ADDENDUM NO. 2

PROJECT: Old City Hall – ADA Implementation

Bid Number: BM2023-1204

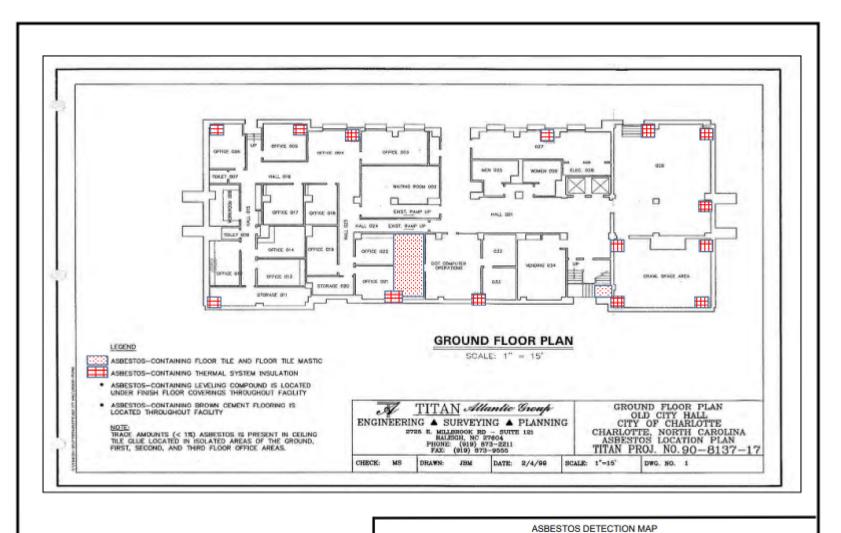
Question: Sheet A503 Detail 5 shows a countersunk backing bracket. Please provide bracket type.

The existing wall appear to be plaster with marble cladding to remain so installing the

bracket must be done through the hole drilled.

Response: Below are the suggested bolts to be used for the following conditions for wall

mounting:

Masonry or stone backing - Hilti KWIK BOLT 3 WEDGE ANCHOR SS304 or similar

O Hollow wall with Marble - Hilti HTB TOGGLE BOLT or similar
